Addendum #1

RFP #CC622-26

BARN 4 RENOVATION

Barn 4 Renovation for Restrooms and Coaches Offices

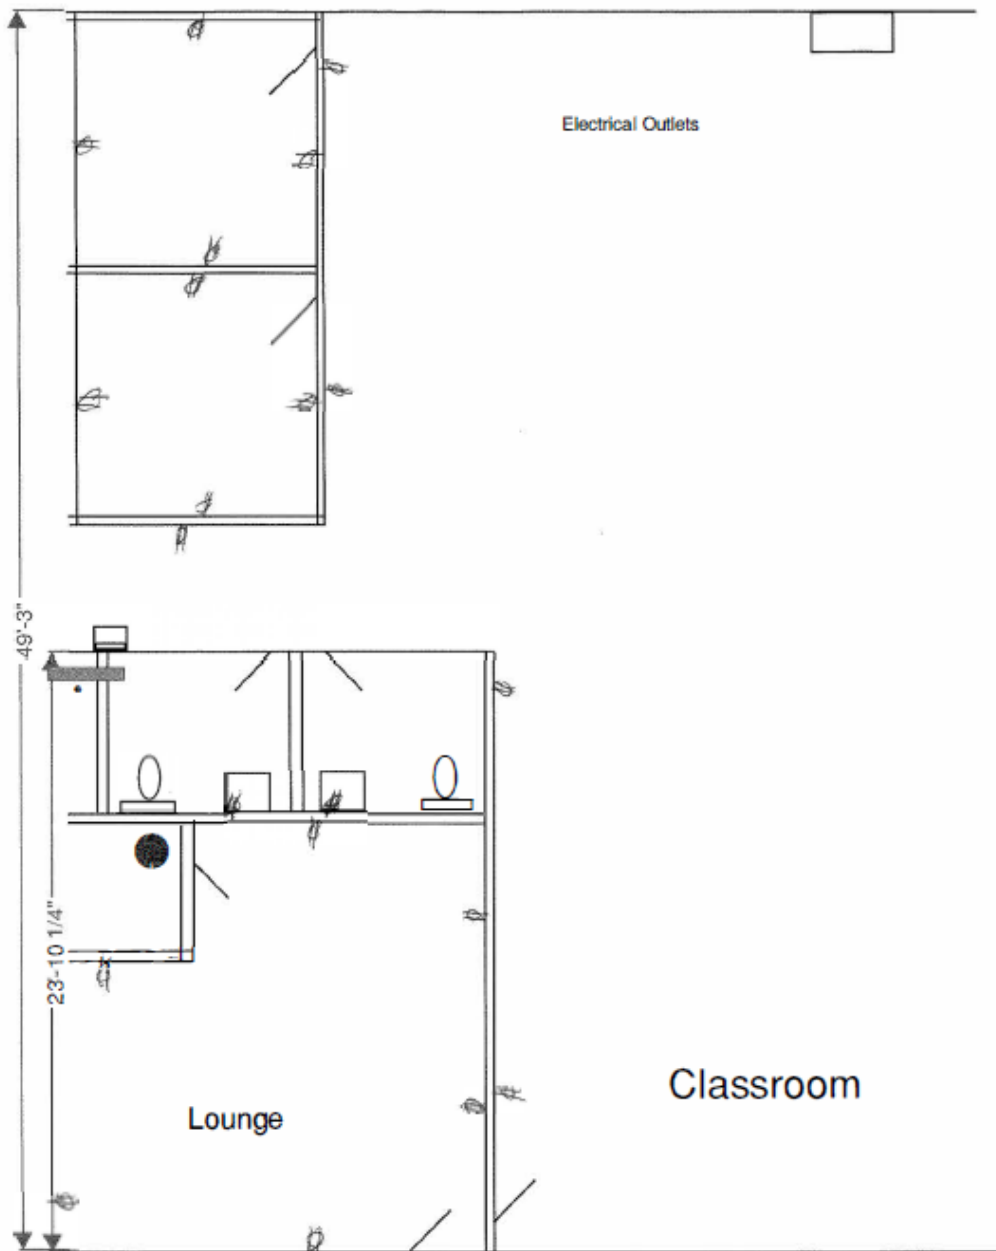
- Does Casper College want wall mounted or cabinet mounted drinking fountains?
 - Wall Mounted
- Does Casper College want the restroom exhaust fans to be roof or side wall penetrations?
 - Side Wall
- We need to mark out the electrical power for the locations of the receptacles.
 - See Attached
- Are we installing a floor drain in the water heater area?
 - Yes
- Heaters in the restroom 110 or 240 Volts?
 - 1000W 120V
- Are there any specs on the lighting to be preferred?
 - Casper College's preference is that all of the lights be LED.
